UNITED STATES PATENT AND TRADEMARK OFFICE

Office Action Summary

10/529,597

KAUPPINEN, JYRKI

(Modified figure 2)

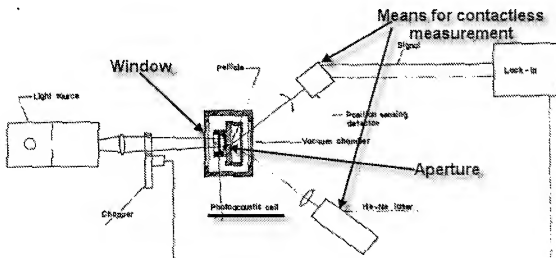
Regarding **Claims 16 & 17**, de Paula discloses and shows in **fig. 2** a microphone for photoacoustics, comprising:

a photoacoustic cell (applicant's first chamber) suppliable with a gas to be analyzed;

a window for letting modulated and/or pulsed infrared radiation and/or light in the first chamber (see modified figure 2);

a means for detecting pressure variations created in the first chamber by the absorbed infrared radiation and/or light, where the means for detecting pressure variations created in the first chamber by absorbed infrared radiation and/or light, comprise:

an duct (applicant's aperture) provided in the wall of the first chamber, in communication with which is provided a pellicle (applicant's door) adapted to be movable in response to movement of a gas (see modified figure 2);

mounting the pellicle slightly laterally displaced in relation to the duct so that one side of the pellicle touches the border of the duct (applicant's door being at least on one side mounted on a frame structure encircling side faces of the door, as discussed above)(Section II, 2nd paragraph).

a means for contactless measurement of the door movement (see modified figure 2);

de Paula does not disclose the door being positioned in the aperture, at least one side mounted so that an inner periphery of the aperture surrounds the door, the door surrounded by a panel-like skirt element, a slit (or gap) exists between the door and the inner periphery of the aperture, and the door has a surface area which is at most equal to the surface area of the aperture;
